January 8, 2016

Subject Technical Review
Interim Remedial Measure Work Plan to Address Oil Infiltration to the
BSA Sewer
Former General Motors and American Axle and Manufacturing Site
Portion of 1001 East Delevan Avenue, 1001 East Delevan Avenue,
General Motors NYSDEC Site Number 915196

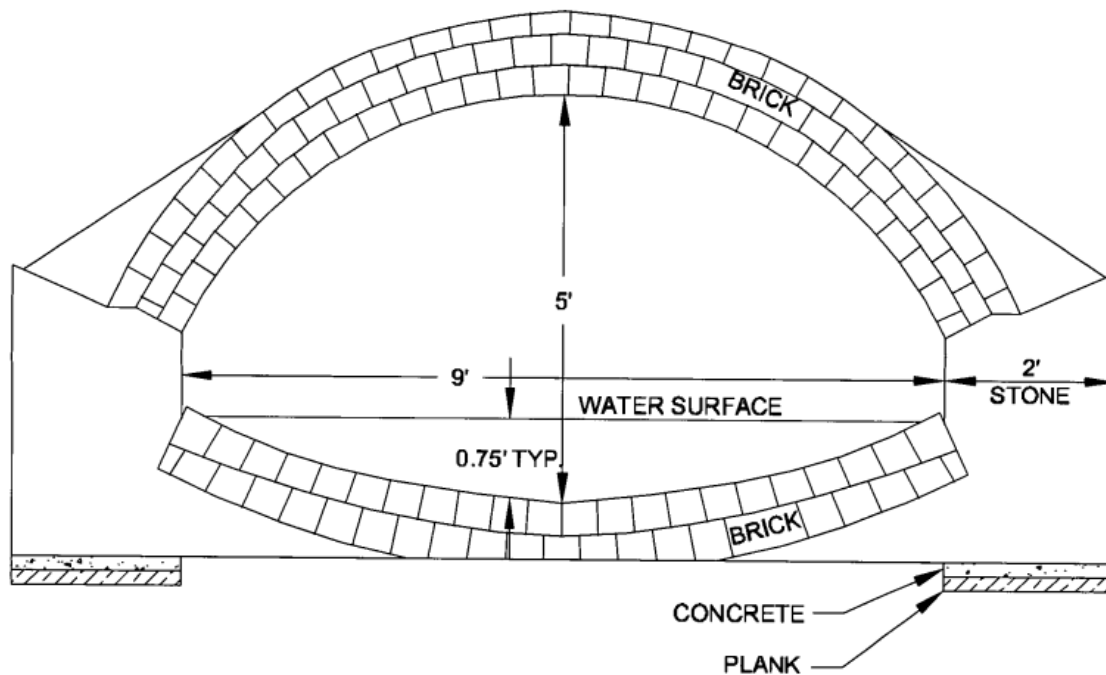
The summary of Nature and Extent of Subsurface PCB Containing Oil (Section 2.2.1.1) cites data on the highest concentrations of PCBs in the subsurface. The data cited are not reflected in the 2009 RI Report as the PCB concentrations in subsequent samples of oil from these same wells were orders of magnitude lower in concentration:

Unit/Well	IRM Report	2006 Sample	2007 Sample
Fill/CP-28	3,850 mg/Kg	59 mg/Kg	69 and 39 mg/Kg
Clay/MW-406	440,000 mg/Kg	700 mg/Kg	27,000 mg/Kg
Bedrock/CP-23	4,350 mg/Kg	NS	0.98 mg/Kg

The data need to be verified given:

1. The dramatic differences in the CRA data set;
2. The fact that the composite samples from the B-26 sump have never exceeded 13 mg/Kg; and
3. The time elapsed from the CRA sampling program to the EDP RI have allowed a more steady state condition to develop.
